Project	IEEE 802.16 Broadband Wireless Access Working Group < http://ieee802.org/16 >	
Title	Changes to 802.16.1 Physical Layer Specification as Agreed on 11 July 2000	
Date Submitted	2000-07-12	
Source(s)	Jeff Foerster Alcatel 1221 Crossman Ave. Sunnyvale, CA 94089	Voice: 408-745-3983 Fax: 408-745-0390 mailto: jeff.r.foerster@alcatel.com
Re:	PHY task group meeting of 2000-07-11.	
Abstract	This contribution documents the changes to the PHY draft specification that were agreed upon during the PHY task group meeting on 2000-07-11.	
Purpose	To document changes in the new working draft (IEEE 802.16.1p-00/07r2).	
Notice	This document has been prepared to assist IEEE 802.16. It is offered as a basis for discussion and is not binding on the contributing individual(s) or organization(s). The material in this document is subject to change in form and content after further study. The contributor(s) reserve(s) the right to add, amend or withdraw material contained herein.

Changes to 802.16.1 Physical Layer Specification as Agreed on 11 July 2000

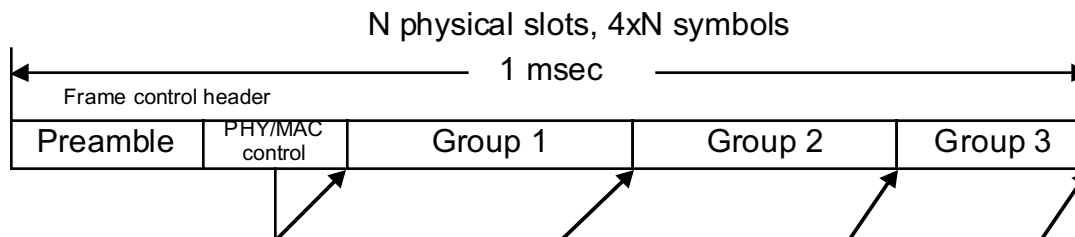
Based upon the various channel conditions and deployment scenarios that are envisioned for BWA systems, there is a desire to have some flexibility in the coding for the burst mode of operation (FDD with adaptive modulation, FSDD, or TDD). In order to address this need, the following approach has been taken in the PHY layer to support this flexibility. The following diagram illustrates the modified frame structure that is used.

In this case, the PHY/MAC control data is treated as a separate group from the user data portion of the frame, which has a clearly defined coding scheme. This PHY/MAC control portion of the frame is used to transmit any pertinent information to the subscribers in order to allow them to enter the network and obtain certain registration information, which includes the configurations of the active modulation and FEC groups for the user data portion of the frame. The rest of the user data portion of the frame is divided into different modulation/FEC groups, where each group is allowed to have different modulation and/or coding structures. The frame should still have the modulation levels increase from QPSK to 16-QAM to 64-QAM, but the coding schemes could be allowed to vary. The downstream allocation map shall contain the location where each modulation/FEC group begins and ends.
